Project 150 Holborn

## Response to comments on the Transport Statement (Planning Application Reference No. 2016/2094/P)

**Figure 1: Proposed Short Stay Cycle Parking at Ground Floor Level**

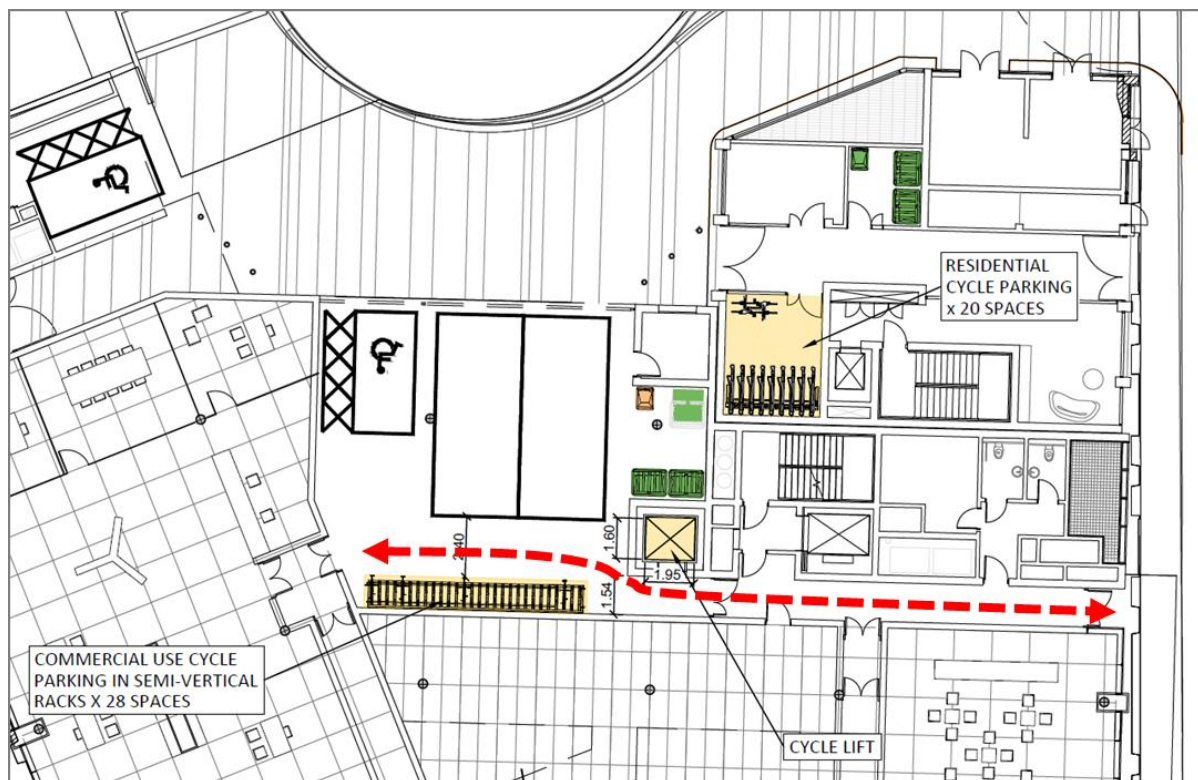
5. The Transport Statement notes that the short stay cycle parking at ground floor level will be provided by semi-vertical stackers. It was requested that the 28 spaces are provided using Josta two-tier stackers instead of the semi-vertical stackers, as the latter is not included in Camden Planning Guidance (CPG) 7: Transport. The implication of this change is that:

- The overall number of cycle parking spaces that can be provided at ground floor level for visitors will be reduced.
  - The layout of the cycle parking using Josta two-tier stackers will reduce the effective access route noted by the red dashed line in Figure 1, which is not considered acceptable, as it introduces a pinch-point of 1.6m metres.

6. For the reasons stated above, the use of semi-vertical stackers is considered to be the better cycle parking option at this site.
7. Appendix A includes the developers specification for the Verti 45 semi-vertical cycle rack produced by Streetsure, which is proposed at the site. The rack allows bicycles to be secured by its frame and front wheel and for bicycles to be easily pushed into place without the need to lift a bicycle. The use of semi-vertical cycle racks is compliant with the London Plan.

8. The provision of 2.4m clearance between the cycle stands and the loading bays is significantly greater than the minimum recommended aisle width specified by the manufacturers and is therefore considered acceptable in the proposed context.

Figure 2: Study Area Access Plan

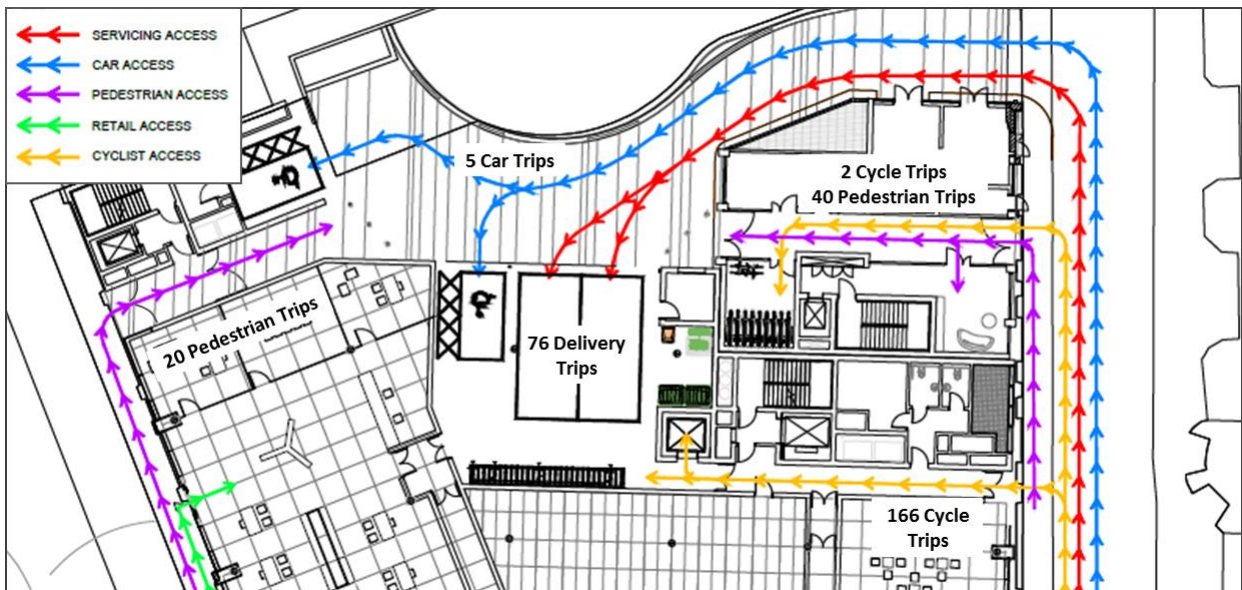
9. It was requested that a Vulnerable User Audit is undertaken of the proposed service/parking area and the walkway between Gray's Inn Road and Brooke Street, using TfL's Road Safety Audit procedure (Document reference: SQA-0170 – May 2014).

12. Figure 2 shows that the potential conflict of vehicle and vulnerable users (pedestrians and cyclists) will be made up of the forecast 5 car trips, 38 deliveries and 20 pedestrian per day that will be required to share the space. In a peak hour the forecast worst case trips will be 2 two-way car trips, 8 two-way delivery trips and 20 two-way pedestrian trips. The potential for pedestrian and vehicle conflict is therefore reasonably low. Measures to improve safety within the shared space are discussed below.

13. The design proposals include the following mitigation measures in order to improve the safety of the shared use space:
- During the peak hours of operation there will be a dockmaster or equivalent security personnel in the vicinity who will be responsible for managing conflicts between modes.
